Access Compliance Report

Public Rights-of-Way

(Curb Ramps)

Intersection ID: 29157	Main Street: STONEY_GARDEN_DR	Cross Street: WALLACE_RIDGE_DR	Location: SW
ADA ID: A78657C9DD02	Ramp Type: BlendTrans1	Initial Pass/Fail: Fail	Overall Compliance: No
Severity Score: 8.75			
Codes/Mitigation Info/Possible Solution		Field Measurements/Component Compliance

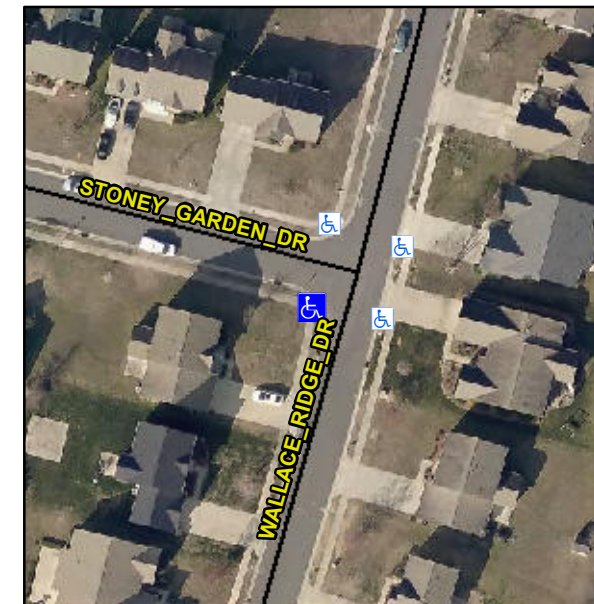
Compliance	Description	Data	Compliance	Description	Data
N/A	Ramp Length (in)	48.0	Yes	BlendTrans Slope (%)	4.3
No	Ramp Width (in)	44.0	Yes	BlendTrans XSlope (%)	1.6
N/A	Flare Type LT	N/A	N/A	Flare Type RT	N/A
N/A	Flare Slope LT (%)	N/A	N/A	Flare Slope RT (%)	N/A
N/A	Flare Traversable LT?	N/A	N/A	Flare Traversable RT?	N/A
N/A	Landing Length (in)	N/A	N/A	DWS Provided?	N/A
N/A	Landing Width (in)	N/A	N/A	DWS Contrast?	N/A
N/A	Landing Slope (%)	N/A	N/A	DWS Length (in)	N/A
N/A	Landing X Slope (%)	N/A	N/A	DWS Full Width?	N/A
N/A	Landing Curb? (Y/N)	N/A	N/A	DWS Offset (in)	N/A
N/A	Shared Landing?	N/A			
N/A	Gutter Ponding?	N/A	N/A	Gutter Slope (%)	N/A
N/A	Gutter Lip Ht (in)	N/A	N/A	Gutter X Slope (%)	N/A
N/A	Painted X Walk1?	No	N/A	Painted X Walk2?	No
	X Walk 1 Direction	To E		X Walk 2 Direction	To N
	X Walk 1 Width (in)	N/A		X Walk 2 Width (in)	N/A
	X Walk 1 Slope (%)	1.3		X Walk 2 Slope (%)	0.1
	X Walk 1 X Slope (%)	0.3		X Walk 2 X Slope (%)	3.7

N/A	Ramp inside XWalk1?	N/A	N/A	Ramp inside XWalk2?	N/A
	Road Slope (%)	1.1		Clear Space?	N/A
	Road X Slope (%)	0.3	N/A	Clear Space to XWalk (in)	N/A
N/A	Any Obstructions?	N/A	N/A	Storm Grate/Utility Hazard?	N/A
	Obstruction Type			Storm Grate/Utility Type	
		N/A			N/A
			Yes	Surface Condition? (G/P)	Good
			N/A	Curb Slope (%)	4.3

Remove & Replace Curb Ramp With Two New Directional Ramps or Equivalent.

R304.5.1
